**Safety Evaluation Report for
Cimarron Corporation
Decommissioning Plan, Revision 3
Amendment 22
Guthrie, Oklahoma**

Materials License No. SNM-0928

Docket No. 070-00925

December 2024

Figure 8-1 $\Delta k_{\text{calc}}/k_{\text{calc}}$ vs. H/C ratio for infinite slab system

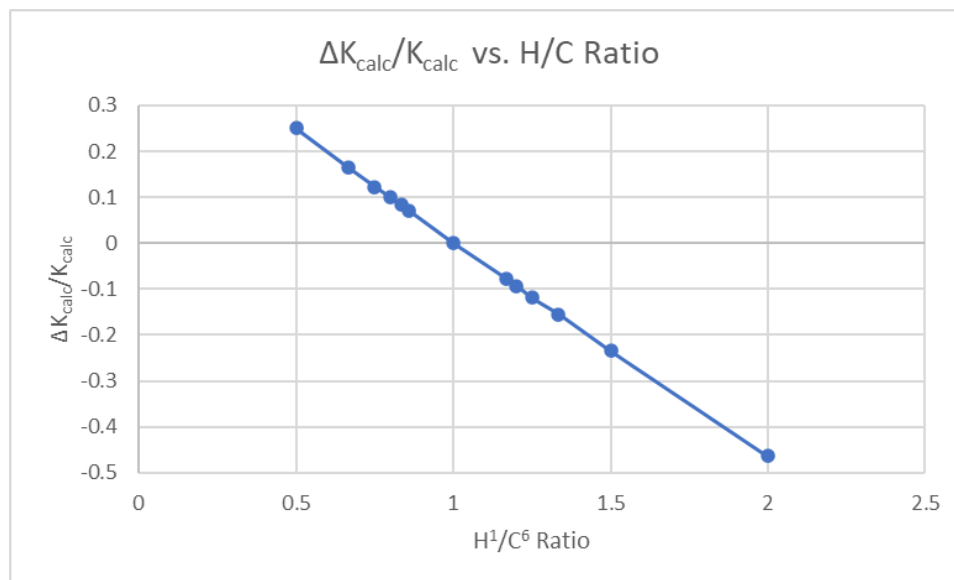
The licensee performed a set of nuclear criticality safety calculations using Monte Carlo N-Particle Transport Code. The calculations used a 7 ft tall rectangular prism with a homogenized resin-UO₂ mixture and a 1 ft thick water reflector above and below the slab. The model used reflective boundary conditions along the rectangular prism to simulate an infinite slab. The fissionable material concentration within the slab was varied from 1 to 10 g of U-235 per kg of resin with modeling assumptions on hydrogen-to-carbon (H/C) ratio, presence of groundwater or lack thereof, resin density, and uranium adsorption.

Hydrogen-to-Carbon Ratio. The resin was assumed to be composed of carbon and hydrogen with an atomic ratio of 1.0. DOWEX 1 IX resin is a copolymer of styrene and divinylbenzene that contains an acid group to facilitate the IX. The molecular formula is C₂₉H₃₄CIN, which has a hydrogen/carbon ratio of 1.18. The licensee stated that the resin-UO₂ mixture is over moderated under all credible conditions, meaning that an assumption of a hydrogen/carbon ratio of 1.0 would be conservative. Additionally, the licensee assumed a dry configuration with no additional Monte Carlo N-Particle application with the ENDF/B-VII.1 continuous energy cross-section library. The staff analyzed a system with the same geometry, a resin density of 1.1 g/cm³, and a uranium enrichment of 7.33 percent U-235. The H/C ratio was varied to evaluate the response in k_{eff} to changes in moderation. The results are shown in figure 8-1, groundwater present. To evaluate whether these assumptions were appropriate, the NRC staff verified that the system would be over moderated under normal and credible abnormal conditions through an independent analysis using the SCALE 6.2.4/KENO-VI.

The staff determined that the reactivity of the system decreases as a function of increasing H/C ratio, confirming over moderation, and that any and all credible moderation upsets would result in a decrease in reactivity. Therefore, the staff determined that the licensee's assumption of no additional groundwater and an H/C ratio of 1.0 would be conservative.

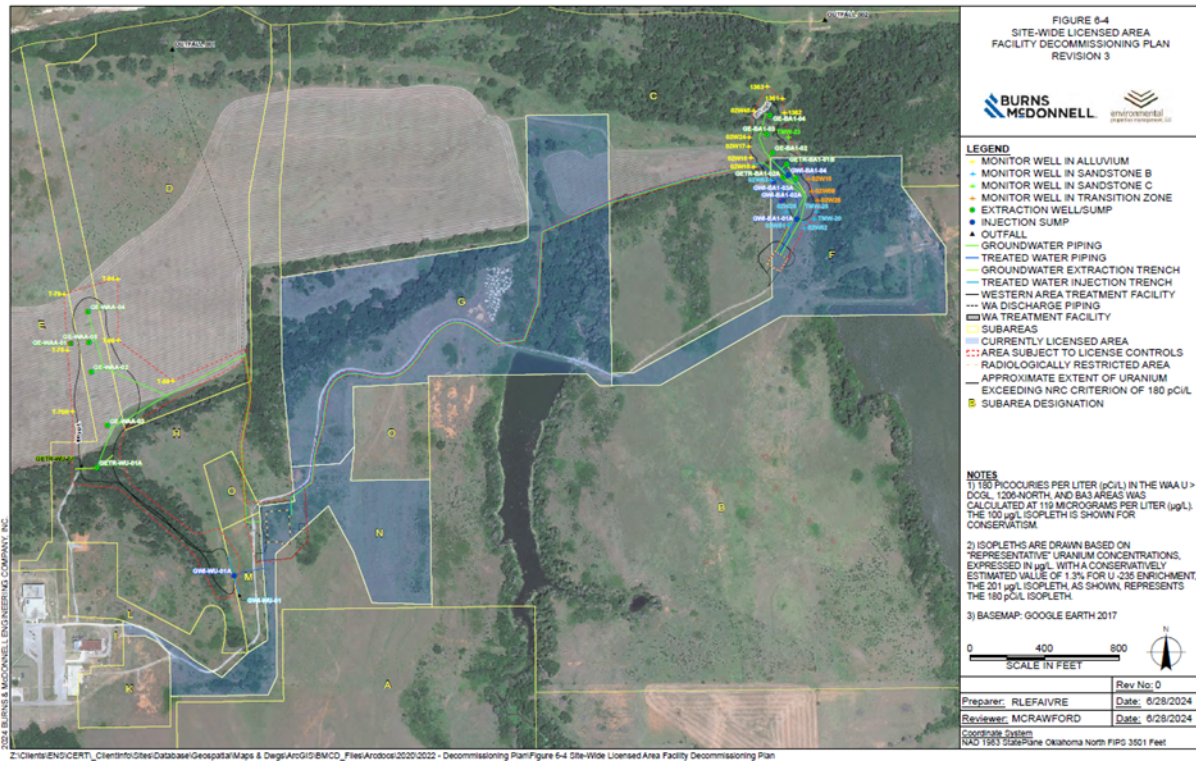
Of the original site of more than 800 ac, only 52 ac remain under license. Figure 6-1 from the DP, Rev. 3, Figures 1-5 ([ML22285A100](#)), shows how the entire former Cimarron site was divided into 16 subareas (as shown in Figure 1-2 ([ML22285A091](#))). It also shows the CERT property boundary as surveyed in 2018; the property line to the north varies as the Cimarron River moves northward across its floodplain.

Subareas A through E, H through M, and O have been released for unrestricted use. LCs 25, 28, 29, and 30 all state that these portions of the Cimarron site have been released for unrestricted use and that they are "...no longer licensed by NRC." FSSs and confirmatory surveys have provided verification that subareas G and N are releasable for unrestricted use, but the NRC has determined that these areas should not be released until groundwater remediation is complete ([ML110280485](#)). The shaded area on figure 6-4 is that portion of the former Cimarron site that remains licensed, as shown on the sitewide licensed area map (figure 6-4) ([ML24192A319](#)).

The purple areas in figure 6-1 show that uranium concentrations in groundwater exceed the NRC criteria in small portions of subareas C, D, E, F, H, and M. Of these, only subareas F, G, and N remain under license, although not specifically identified in LC 9. The areas currently defined as being regulated are discussed in Order Transferring License No. SNM-928 for the Cimarron site, dated August 14, 2011 ([ML110280485](#)). Specifically, areas currently covered by the license are defined in a paragraph on page 2 of the order:

Final status surveys and confirmatory surveys have confirmed that Subareas G and N are releasable for unrestricted use, but NRC has determined that these areas should not be released until groundwater remediation is complete. Because groundwater exceeds license criteria in Subarea F, this area cannot be released for unrestricted use until groundwater remediation is complete.

This means that subareas G, N, and F define the currently licensed areas. Figure 6-4 identifies these three areas, versus the areas no longer under license. Figure 6-4 was submitted as Attachment 3 to EPM's July 3, 2024, comments on the draft Environmental Assessment ([ML24185A228](#)).

The licensee’s Cimarron Uranium Plant, located 1/2 mile North of Highway 33 and Highway 74 junction near Crescent, Oklahoma, with areas defined by the map in Figure 6-4, which was submitted as Attachment 3 to EPM’s July 3, 2024, comments on the draft Environmental Assessment ([ML24185A228](https://www.epl.com/ML24185A228)).
